PEGATRON		Title : NB ****	
Pegatron BU2 HW Team 3		Engineer: Kevin1_Guo	
Size	Project Name		Rev
Custom	G60VX		R 1.2
Date: Thursday, March 05, 2009		Sheet	16 of 100

G60VX

R1.2

U0301D

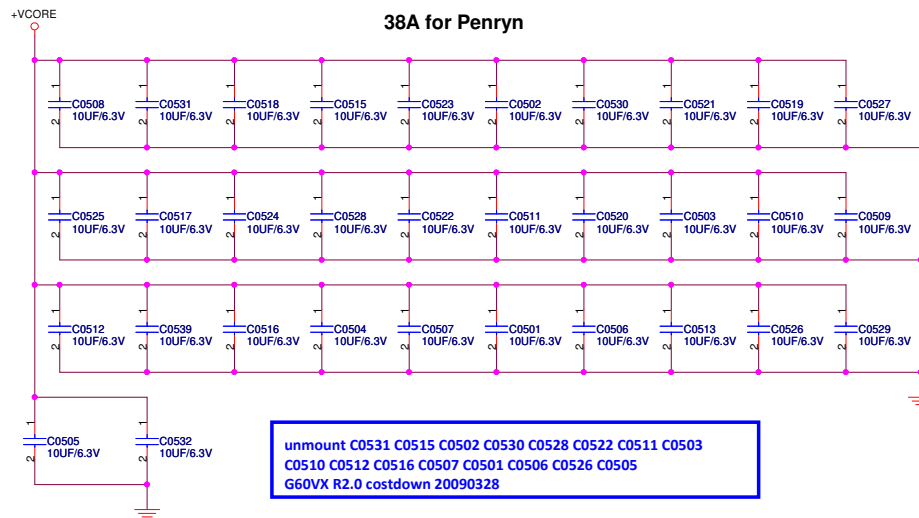
unmount or delete C0538 C0537 C0536
G60VX R2.0 costdown 20090328

+VCCORE Mid-Frequency Capacitor
Intel: 22uF *32
F3S: 10uF *16
A7S: 10uF *1011/17
V1V: ?

+VCCP Decoupling Capacitor
Intel: 270uF *1, 0.1uF *6
F3S: 100uF *1, 0.1uF *4
V1V: ?

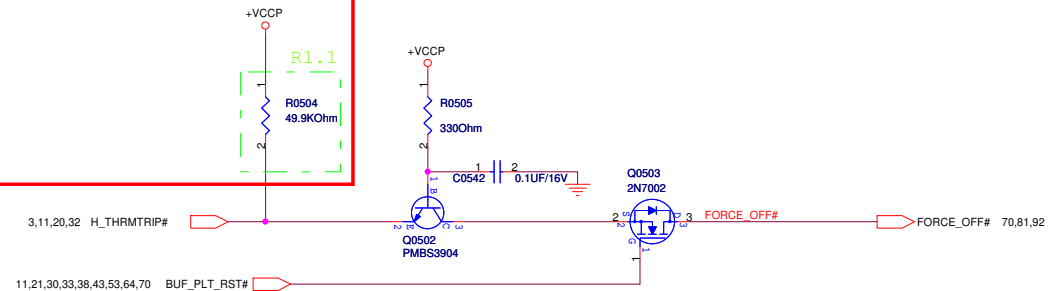
Checklist recommends THERMTRIP# pull up in the CPU side although functionality not used;
DC: 56 ohm pull up, 55 ohm terminate;
QC: 50 ohm pull up, 50 ohm terminate
200811190902

unmount R0504 R0505 C0542 Q0502 Q0503
connect H_THRMTRIP# to SB to costdown
G60VX R2.0 costdown 20090328

Pegatron Title : CLK_ICS9LPR363

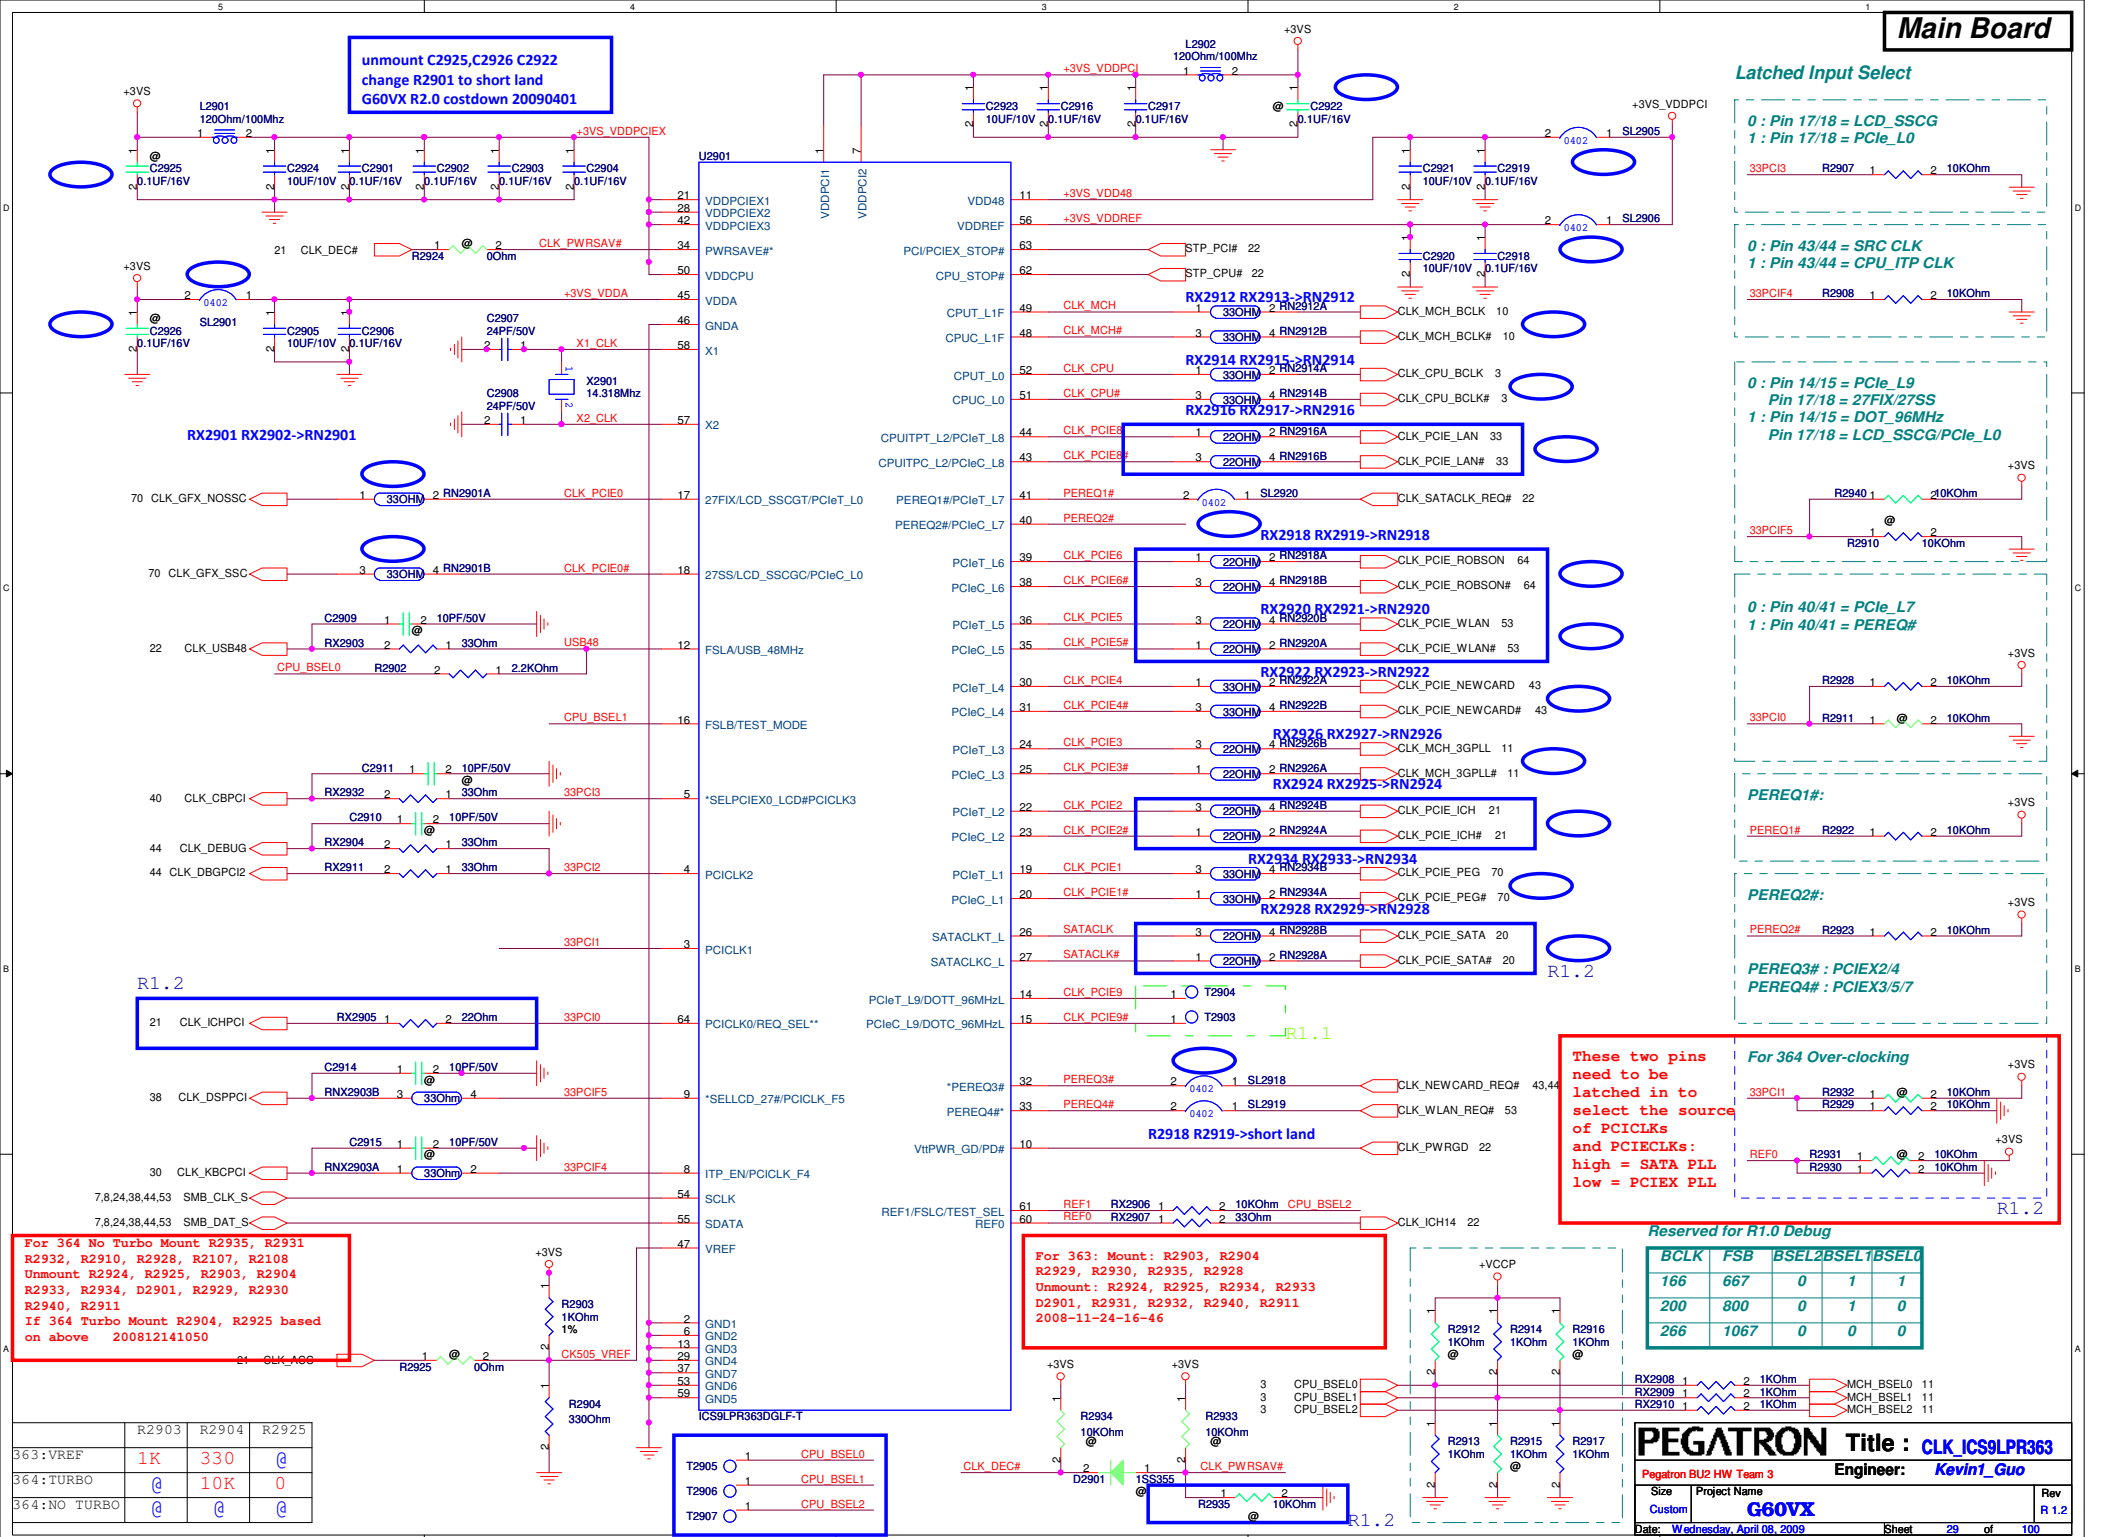
For 364 No Turbo Mount R2935, R2931
R2932, R2910, R2928, R2107, R2108
Unmount R2924, R2925, R2903, R2904
R2933, R2934, D2901, R2929, R2930
R2940, R2911
If 364 Turbo Mount R2904, R2925 based
on above 200812141050

R2903	R2904	R2925
363:VREF	1K	330	@
364:TURBO	@	10K	0
364:NO TURBO	@	@	@

For 363: Mount: R2903, R2904
R2929, R2930, R2935, R2928
Unmount: R2924, R2925, R2934, R2933
D2901, R2931, R2932, R2940, R2911
2008-11-24-16-46

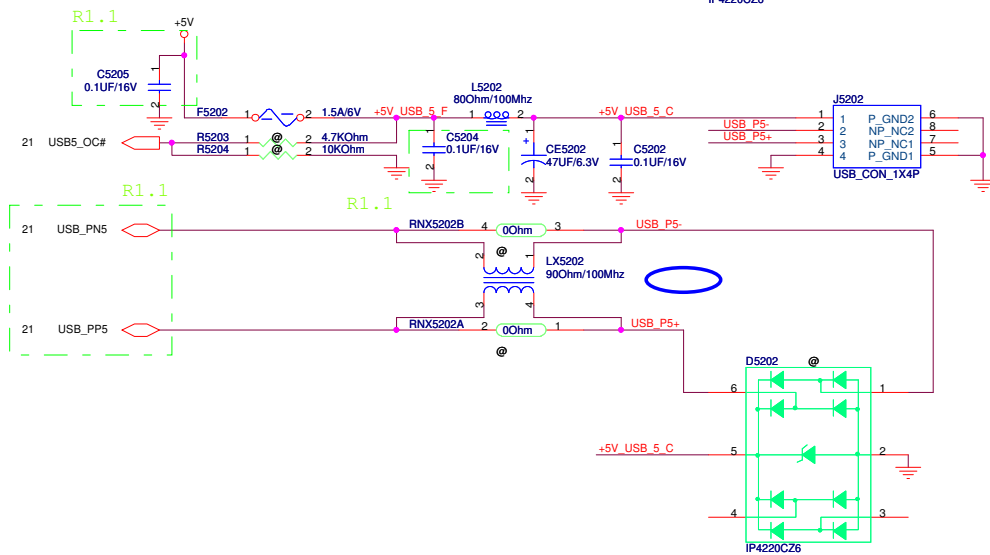
need Verification !
G60VX R2.0 costdown 20090402

Follow H15HV R2.1 to accommodate large current
for Intel WiFi link 5300/5100 WLAN card
G60VX R1.2 20090305

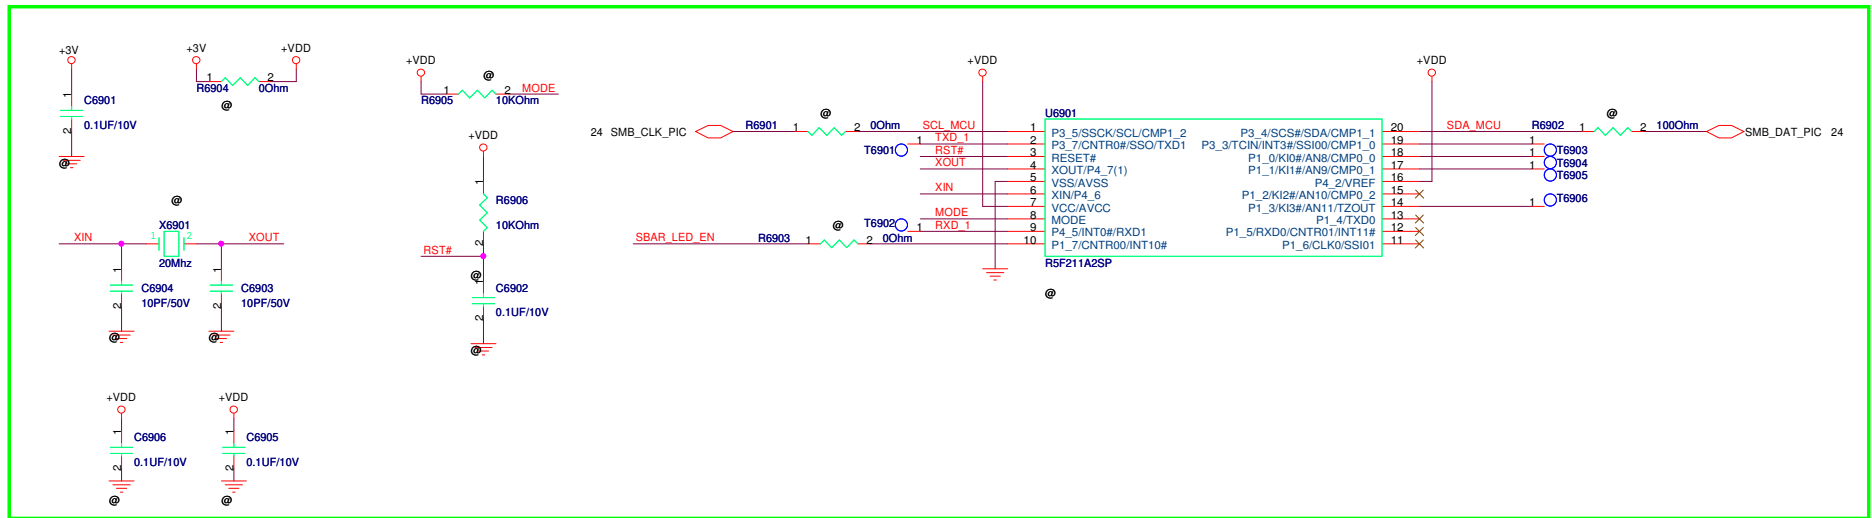
Cause EC will control GAME_LED#
Mount R6907 R6908, unmount
all others and Q2402 RN2402
G60VX R1.2 20090305

G50VX V1.0, Change net GAME_LED_EC# from
connecting with EC.GPA3 pin to connecting with
EC.GPA6 pin
2008-11-24-19-54

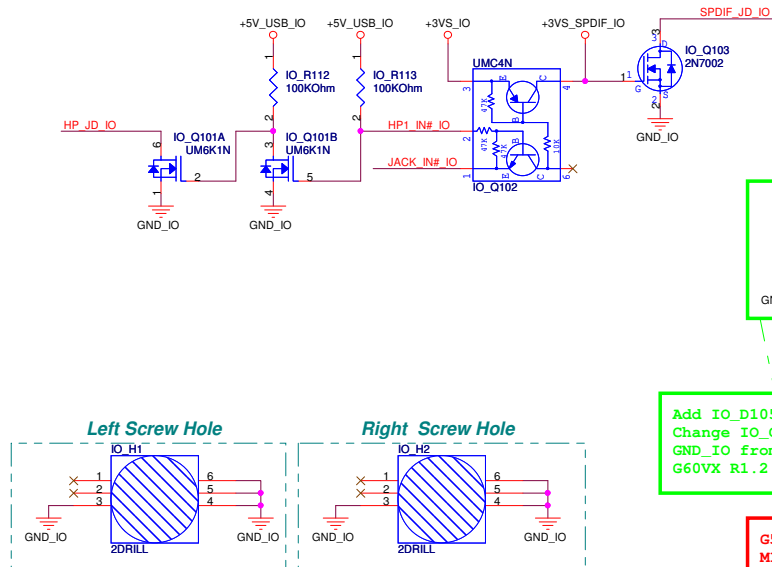
Add IO_D105, IO_D106 for ESD protection
 Change IO_C111 and IO_C110 GND to
 GND_IO from GND_ADO for layout
 G60VX R1.2 20090304
